Subject: MHI's Response to NRC's Request for Additional Information on US-APWR

Topical Report MUAP-07010-P, Non-LOCA Methodology

MHI's Response to NRC's Request for Additional Information on US-APWR Topical Report MUAP-07010-P, Non-LOCA Methodology

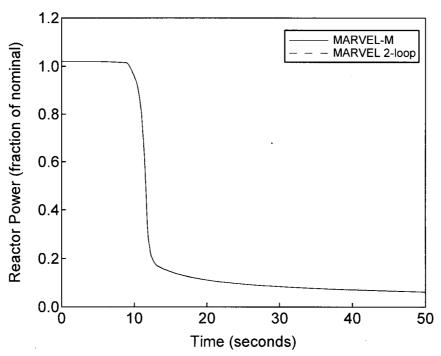
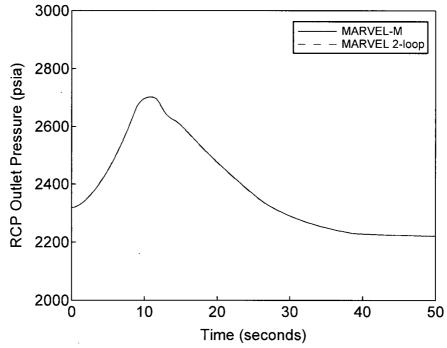
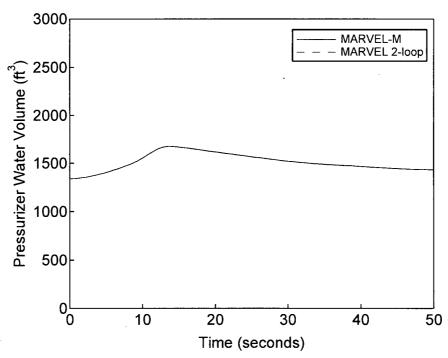
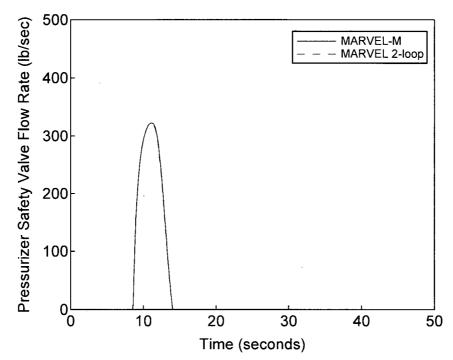
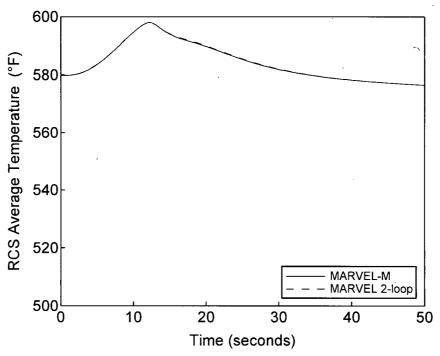
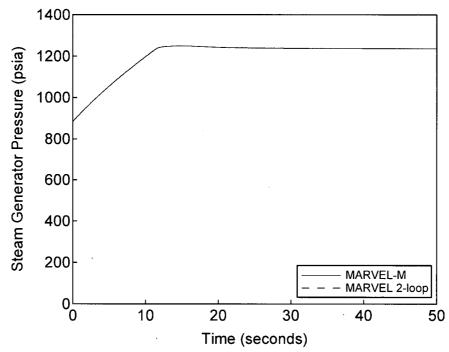
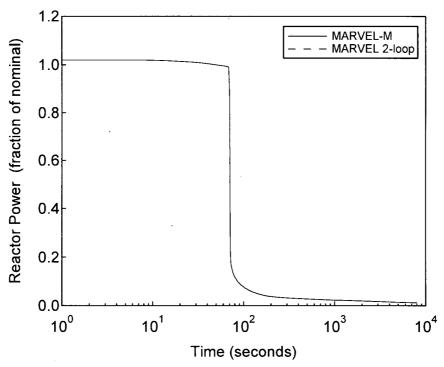
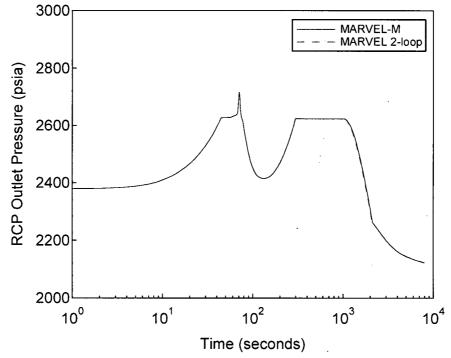
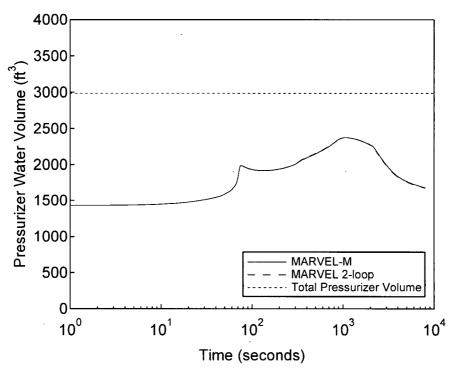
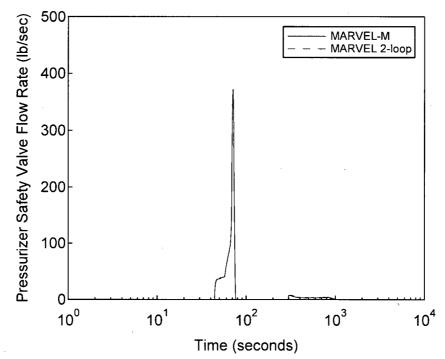
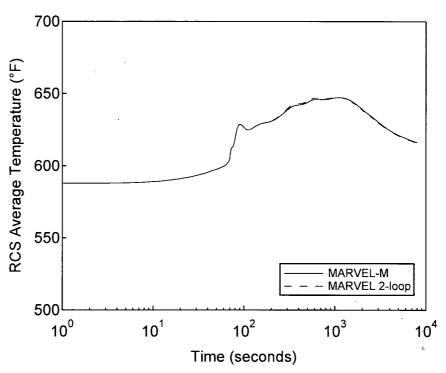
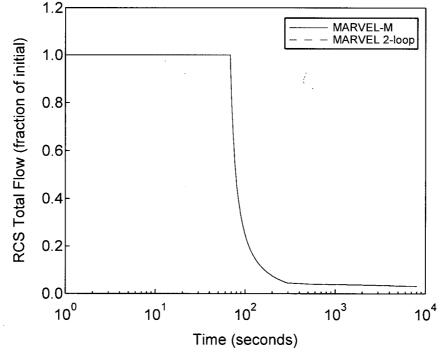
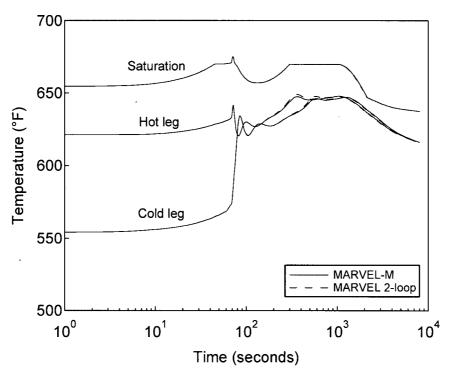
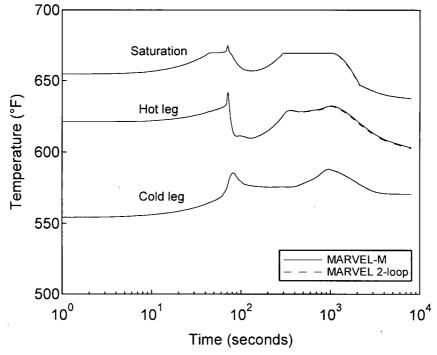
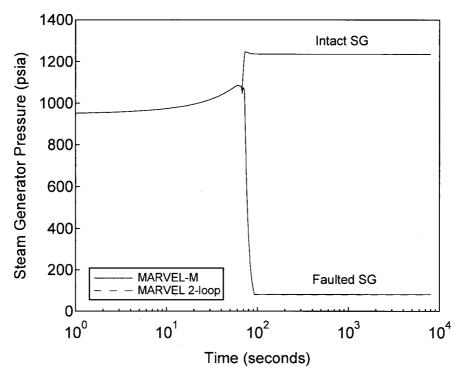
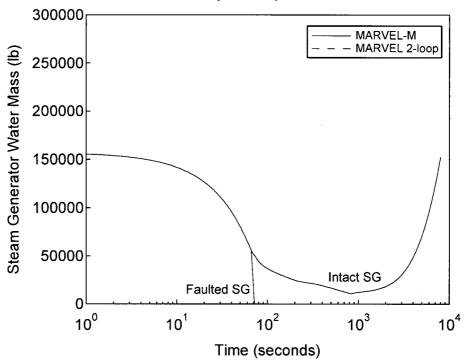
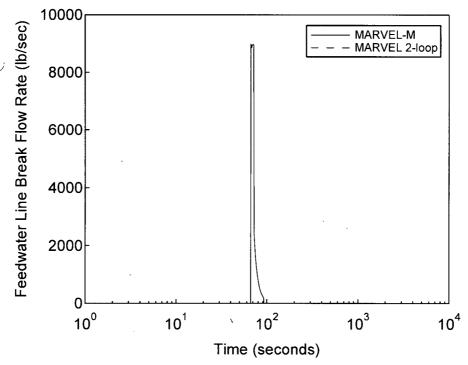
Have any MARVEL/MARVEL-M code comparisons been performed? Please provide a MARVEL/MARVEL-M code comparison for a typical 2-loop calculation.

Comparisons between the MARVEL and MARVEL-M codes have been performed for non-LOCA events as a verification of the extension from a 2-loop simulation to a 4-loop simulation. The results of these comparisons are introduced in the following figures. Figures 2.1-3.1 through 2.1-3.6 show the comparison of "Loss of Load" as a uniform event and Figures 2.1-3.7 through 2.1-3.17 show the comparison of "Feedwater System Pipe Break" as a non-uniform event. The 4-loop MARVEL-M case is set up to assume the break in a single loop with all of the remaining loops receiving the same emergency feedwater flow. This allows a direct comparison with 2-loop MARVEL, which models these loops as a single loop. Both the 2-loop MARVEL and 4-loop MARVEL-M runs utilize the hyperbolic coast down reactor coolant pump model, again allowing for direct comparison of the code output.

The results demonstrate nearly exact agreement between the 2-loop and 4-loop codes for both primary and secondary parameters of interest.

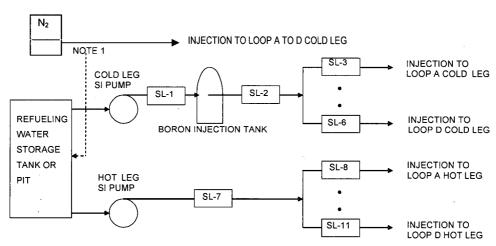
Please provide the details of cold leg injection by the safety injection system and its role in non-LOCA events.

As shown in the schematic drawing below from the MARVEL-M code manual, MARVEL-M has the capability to model several different safety injection system configurations. The upper flow path shown on the figure below models one SI pump, a common discharge header, and flow split to the four cold legs. This flow path model includes a Boron Injection Tank consistent with earlier plant designs. For newer plant designs such as the US-APWR that do not have a boron injection tank, this volume can be set to zero. Because for non-LOCA accidents the reactor coolant (RCS) pressure is the same at the cold leg inlets, one or more trains of SI pumps can be modeled with a single pump, as shown in the figure.

The lower flow path shown on the figure models a second single SI pump, a common discharge header, and flow split to the four hot legs. The user can select the injection point as the hot legs, the deluge line, or the reactor vessel downcomer.

Figure 2.1-17.1 Loss of Non-Emergency AC Power to the Station Auxiliaries Comparison between LOFTRAN and MARVEL-M (1)

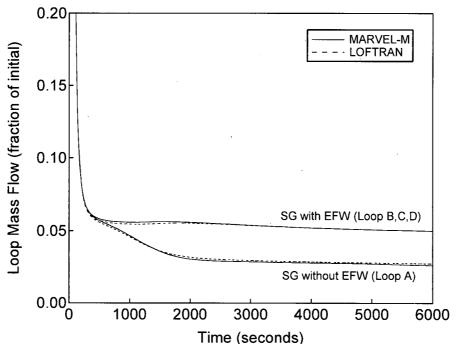
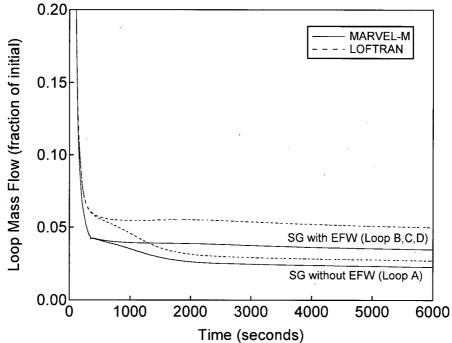
Transition to natural circulation flow is modeled in MARVEL-M and the elevation head equations are typical. Has this model been tested against scaled experimental data? If so, please provide comparisons.

The MARVEL-M transient flow model has not been compared to scaled experimental data. However, the MARVEL-M model has been compared with LOFTRAN (in a manner similar to the code comparisons provided in MUAP-07010 Section 3) in order to verify the natural circulation model.

Figure 2.1-17.1 shows the loop mass flow rate comparison between MARVEL-M and LOFTRAN for the "Loss of Non-Emergency AC Power to the Station Auxiliaries" event. The natural circulation flow of both the loop without emergency feedwater (EFW) and the loops with EFW after the reactor coolant pump (RCP) coastdown have very good agreement.

The US-APWR safety analysis assumes a conservative lower limit on the friction and windage torque utilized in the MARVEL-M RCP model. (See the response to RAI 2.1-7 for details on the RCP model.) The MARVEL-M results presented in Figure 2.1-17.1 do not include this conservative limitation in order to better compare the results with the LOFTRAN code. Figure 2.1-17.2 presents the results of the case where the safety analysis assumed friction and windage torque lower limit is used in MARVEL-M compared with the same LOFTRAN results previously shown in Figure 2.1-17.1. The figure demonstrates that the safety analysis MARVEL-M predicted results show a larger decrease in flow rate and a lower stable natural circulation flow level than predicted with LOFTRAN. In the DCD Chapter 15 analyses of the US-APWR, this conservative assumption is used in events that feature natural circulation flow conditions.

Figure 2.2-1.1 Flowchart of the Discontinuity Factor Process

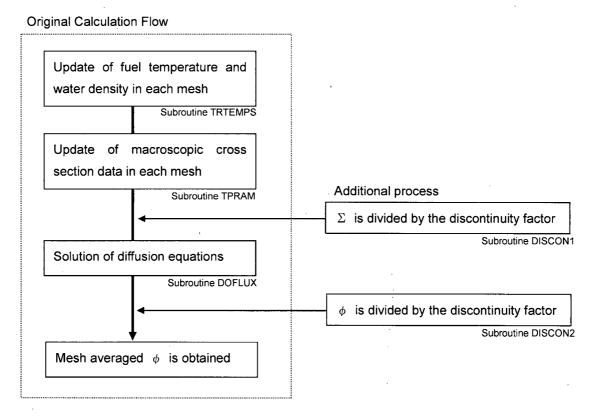
There are several differences between TWINKLE and TWINKLE-M that are mentioned but not discussed in any detail. The introduction of more spatial points and discontinuity factors suggests that the numerical algorithm for solving the diffusion equations may have also been changed although it is not stated. Please list all changes and provide additional description of the differences between the codes.

A discontinuity factor was added as a new input process in the program. The purpose of the discontinuity factor is to improve the representation of the local power distribution in the three-dimensional calculations. The addition of the discontinuity factor does not change the diffusion equations in TWINKLE. Instead, the discontinuity factor implementation is shown in Figure 2.2-1.1 and described as follows:

- The macroscopic cross section data is divided by the discontinuity factor before solving the diffusion equations (additional process).
- The neutron flux is solved using the unchanged TWINKLE diffusion equation subroutine.
- The neutron flux is divided by the discontinuity factor to determine the mesh averaged neutron flux (additional process).

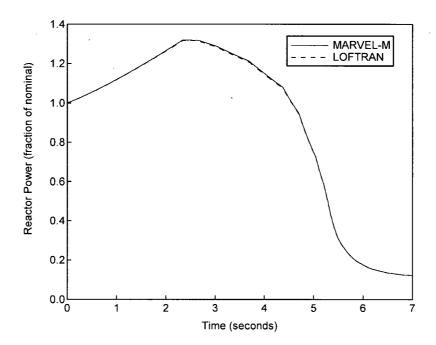
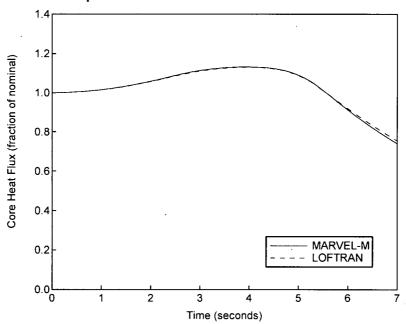
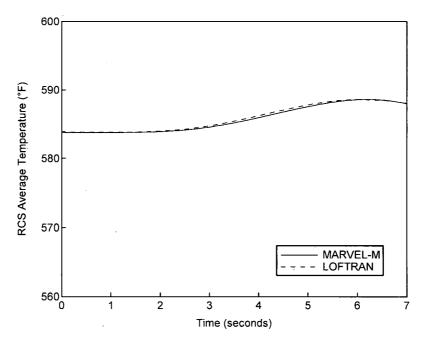
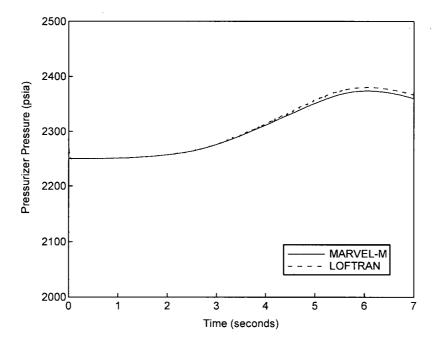
Please provide documentation of MARVEL-M/LOFTRAN code comparisons that may not be in agreement (if available), along with any explanations for the deviations.

The overall agreement between MARVEL-M and LOFTRAN is generally quite good. This response describes a case where a difference between the two codes has been noticed, but can be explained based on known differences in the code models.

MUAP-07010 Section 3.1.1 provides a comparison between MARVEL-M and LOFTRAN for the Uncontrolled RCCA Bank-Withdrawal at Power event assuming the pressure control system is turned off. While performing a similar comparison for the same case except with pressurizer pressure control, slight differences were observed in the pressurizer pressure response. After further review, the differences in RCS response for the LOFTRAN and MARVEL-M analyses were shown to be attributed to the following differences between the spray models in LOFTRAN and MARVEL-M:

Figures 3.1-2.1 through 3.1-2.4 show the comparison between MARVEL-M and LOFTRAN for the case where the pressure control system is available assuming the pressurizer spray is actuated by the actual pressurizer pressure signal. The LOFTRAN predicted RCS pressure is slightly higher than the MARVEL-M code prediction due to the previously described spray model differences. Because the differences occur below the safety valve pressure, differences in the safety valve models have been ruled out as the cause for the differences. In addition, as stated above, the transient comparison without pressurizer pressure control is virtually identical. The other transient parameters have good agreement between the two codes.

Figure 3.1-3.1 DNBR versus Time

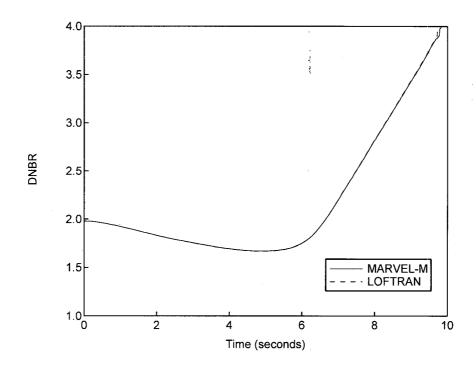
Please provide the DNBR vs. t for the partial loss of forced reactor coolant flow analyses for both MARVEL-M and LOFTRAN.

As a clarification, DNBR is calculated by the VIPRE-01M code for this event using power and flow calculated by either MARVEL-M or LOFTRAN. The figure below provides a comparison of the DNBR for the partial loss of forced reactor coolant flow event. The two codes provide identical DNBR results for this event.

Figure 3.1-4.1 DNBR versus Time

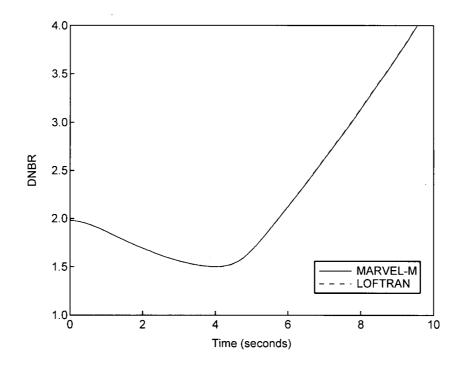
Please provide the DNBR vs. t for the complete loss of forced reactor coolant flow analyses for both MARVEL-M and LOFTRAN.

As a clarification, DNBR is calculated by the VIPRE-01M code for this event using power and flow calculated by either MARVEL-M or LOFTRAN. The figure below provides a comparison of the DNBR for the complete loss of forced reactor coolant flow event. The two codes provide identical results for this event.

Figure 3.1-5.1 DNBR versus Time

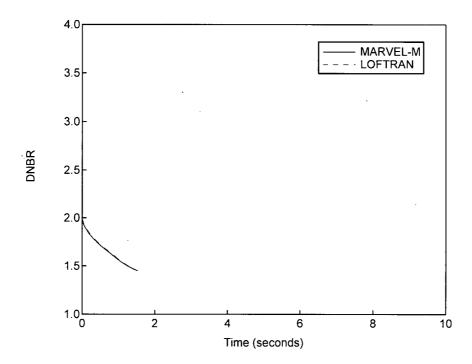
Please provide the DNBR vs. t for the partial reactor coolant pump shaft seizure analyses for both MARVEL-M and LOFTRAN.

As a clarification, DNBR is calculated by the VIPRE-01M code for this event using power and flow calculated by either MARVEL-M or LOFTRAN. The figure below provides a comparison of the DNBR results for reactor coolant pump shaft seizure event.

Note that the figure only shows the DNBR transient until the DNBR reaches its safety analysis limit. The two codes show identical results for this transient.
